<b>APPLICATION NO.</b>	<a href="#">P18/V0301/FUL</a>
<b>SITE</b>	Land East of Milton Hill Abingdon
<b>PARISH</b>	MILTON
<b>PROPOSAL</b>	Variation of condition 2 (approved plans) of planning permission P16/V2900/FUL.(as amended by drawings received 19 April 2018).
	(Development comprising 458 dwellings with associated public open space, infrastructure and improved sports facilities. Reservation of land for future primary school expansion).
<b>WARD MEMBER(S)</b>	Michael Murray
<b>APPLICANT</b>	Mr David Bent
<b>OFFICER</b>	Liz Fay

## Vale of White Horse District Council – Committee Report – 9 May 2018

**Appendix 1: Amendments made to south-western boundary**

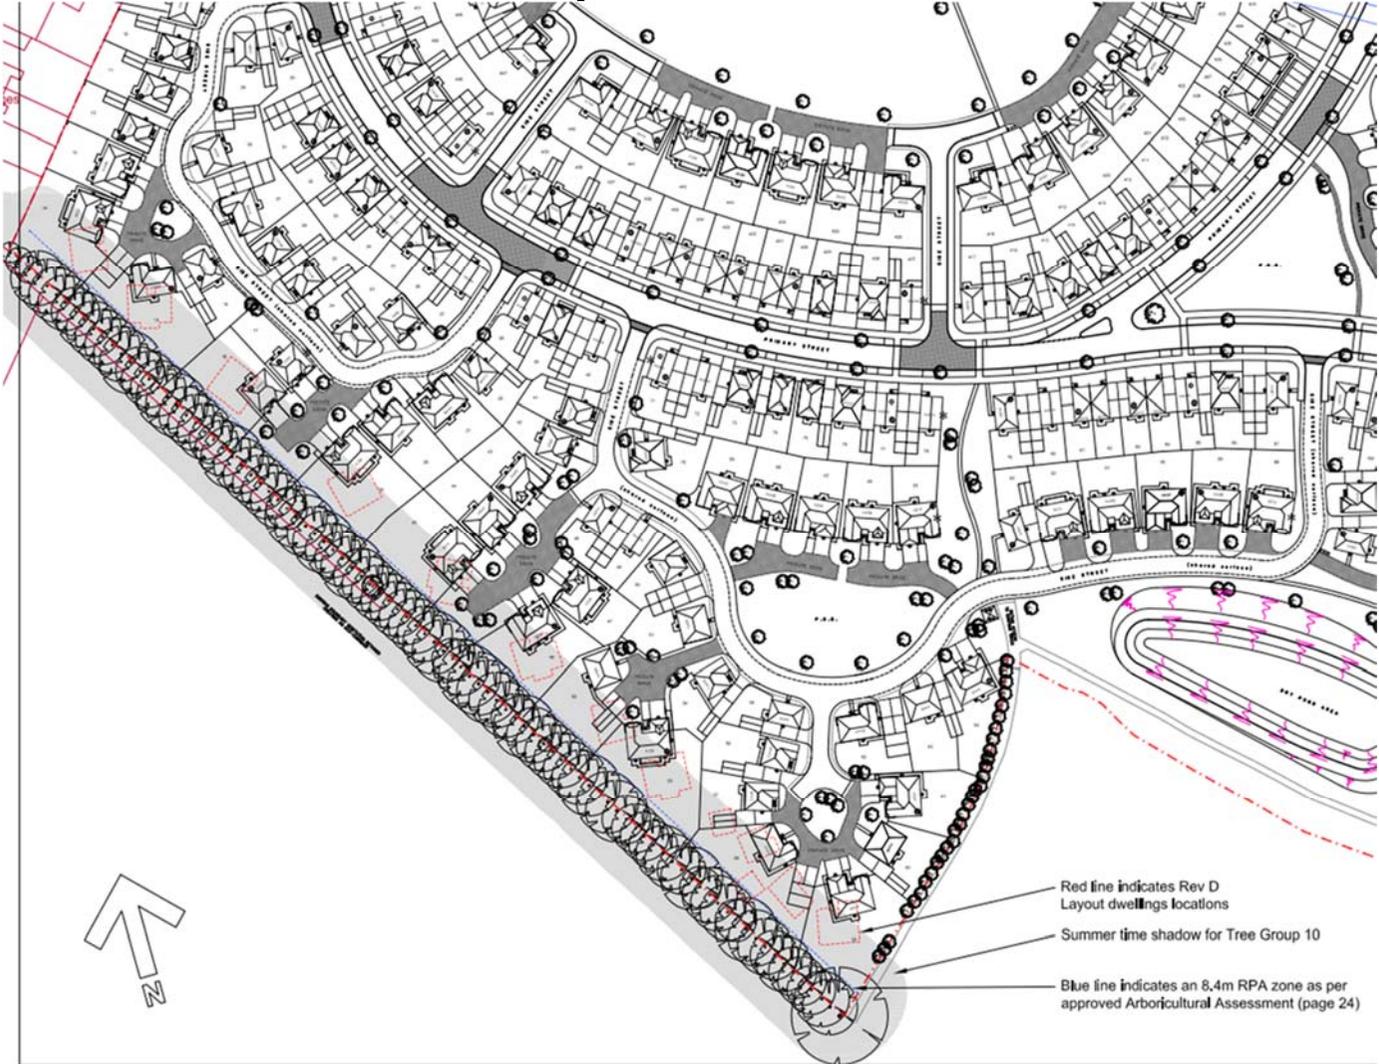
- 5.31 Plots 14-18, 19, 45-46, 52, 53, and 57-59 along the south-eastern boundary of the site are located in close proximity to a row of poplar trees situated just to the south-east of the site. The properties are located significantly closer to the boundary than was the case on the extant permission. I consider this issue more fully below, however, it is likely that the existence of the poplar trees will have an impact on residential amenity, caused by the over-shadowing and proximity of these trees. It is not possible to fully assess the impact as full details of the extent of the canopies of these trees, along with the amount of shading they provide, has not been submitted alongside this application. However, it is probable that the impact is significant and possible that the dwellings may be located below the canopies of the trees. In the absence of evidence to the contrary, it is not possible to conclude that the amended plans comply with saved policy DC9 of the Local Plan 2011 and Design Guide principle DG63.

- 5.36 The amended plans provide dwellings which back onto the southern boundary, and the poplar trees. These dwellings are detached properties on relatively large plots, but they are still located in close proximity to the boundary, with the closest dwellings being only 7m from the boundary. The applicant's Arboricultural Report supplied with the extant permission indicated that the root protection areas for these trees extends approximately 10m into the site. The applicant's Arboricultural Report has not been updated to provide detailed information on how the proposed layout would impact on the poplar trees, although the applicant has stated that it would be possible to build the proposed dwellings without damaging the trees this statement has not been supported by evidence. My assessment of the amended plans is that significant parts of the proposed dwellings would require construction within the area proposed for protection by a Tree Protection Barrier within the applicant's Arboricultural Report. It is not clear from the information provided that it is possible to carry out the construction of the dwellings without damaging the roots of the poplar trees.

- 5.37 The Council's Tree Officers has raised an objection regarding the proximity of development to the poplar trees, and the Council's Landscape Officer has also raised concerns. There is the risk of conflict between the occupants of plots to the south-eastern boundary and enjoyment of the available garden space, as well as the perception of insecurity given the height of the trees and the propensity of poplar trees to shed small branches. The Council's Tree Officer has advised that the amended layout is not compatible with the long-term retention of the trees.

- 5.39 Any properties built underneath, or in close proximity to, to the canopy of these trees, will be affected by leaf loss blocking gutters, falling branches and considerable overshadowing of the property and its garden. This will result in a lack of light to both the open-plan kitchen/dining/family rooms that are provided to the rear of these properties, and which would be likely to be used by the occupants as their main living space, and the rear-facing first floor bedrooms. This will lead to considerable pressure to prune or remove the trees.
